ENVIRONMENTAL ASSESSMENT
FOR HYDROPOWER LICENSE

Carver Falls Hydroelectric Project
FERC Project No. 11475-000
New York/Vermont

Federal Energy Regulatory Commission
Office of Hydropower Licensing
Division of Licensing and Compliance
888 First Street, N.E.
Washington, DC 20426

Figure 1
Project Location Map
Carver Falls Environmental Assessment
 Source: CVPS, modified by staff.

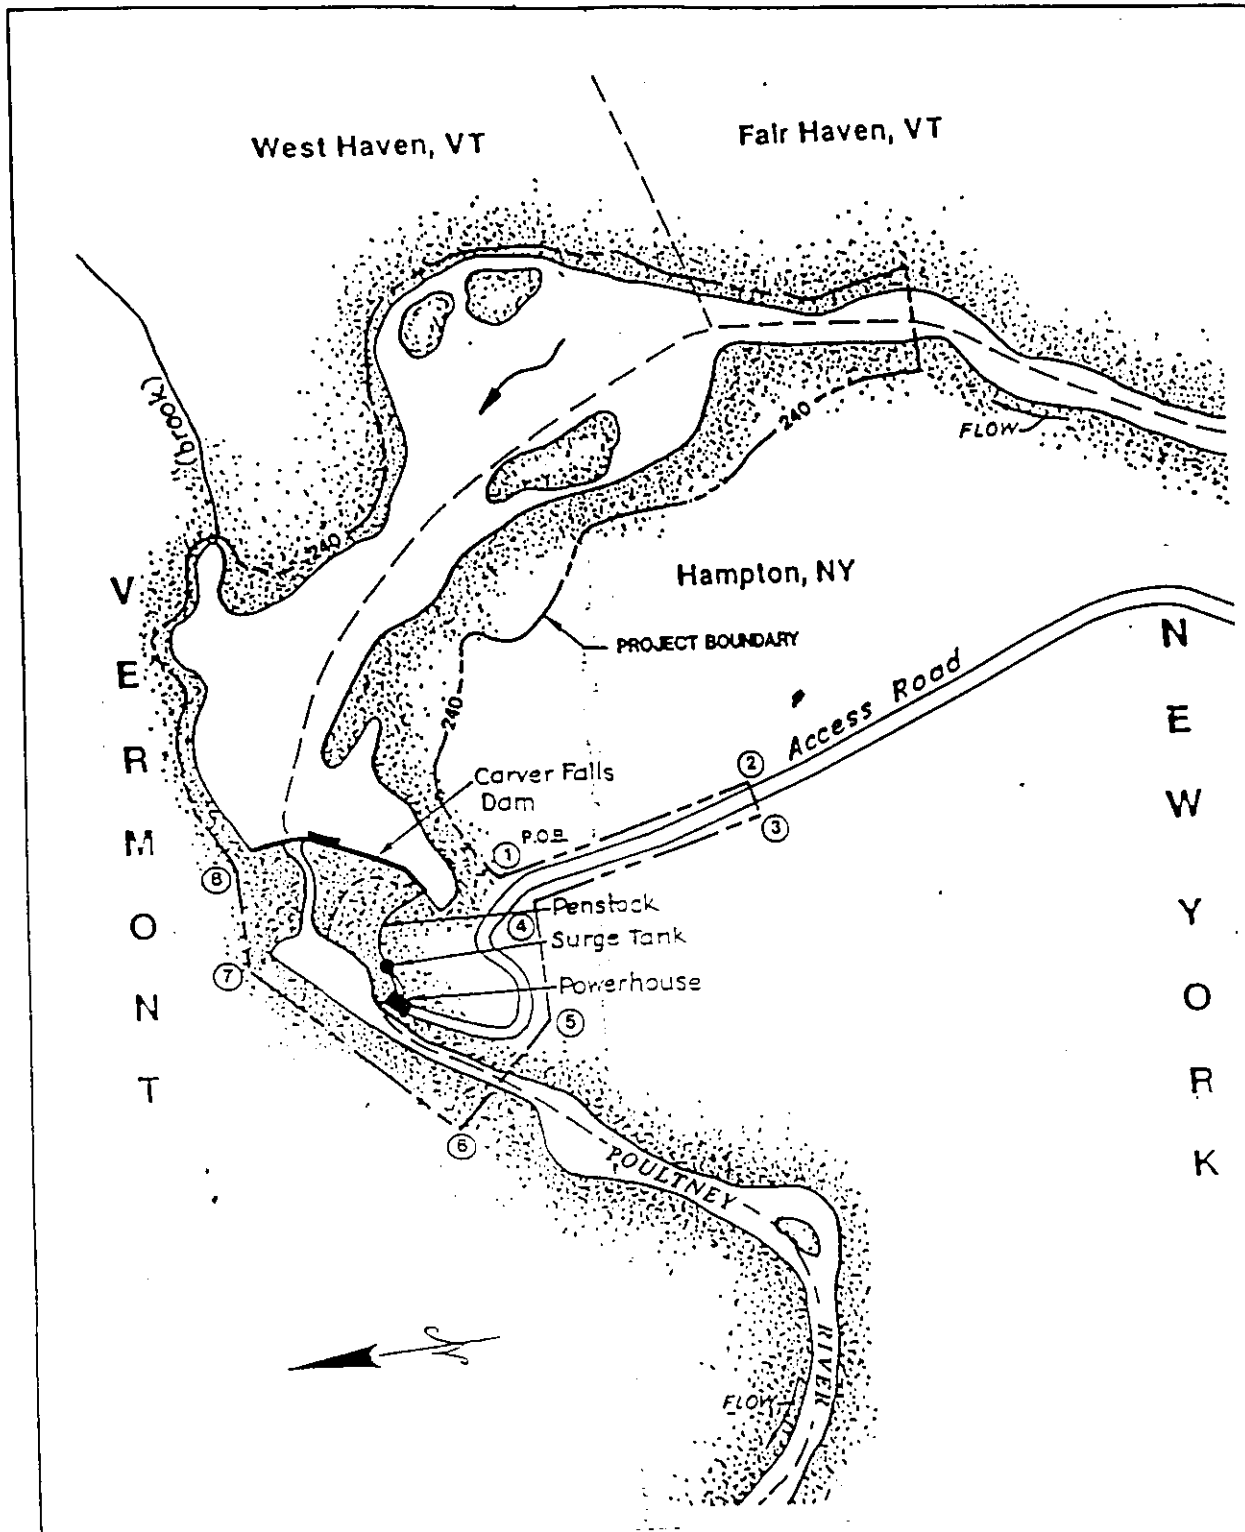
The boundary between the States of Vermont and New York, illustrated on Figure 1 of the DEA, cuts through the middle of the northern spillway. As such, the old headworks and penstocks are entirely within the State of New York. Therefore the consultation with the Vermont SHPO on the removal of the old penstocks suggested on page 39 should be revised to consultation with the New York SHPO.

CVPS-11. Our review of Figure 1 and the penstock removal analysis on page 39 of the DEA confirm this comment. We modified our recommendation concerning SHPO consultation to require consultation with the New York SHPO on penstock removal.
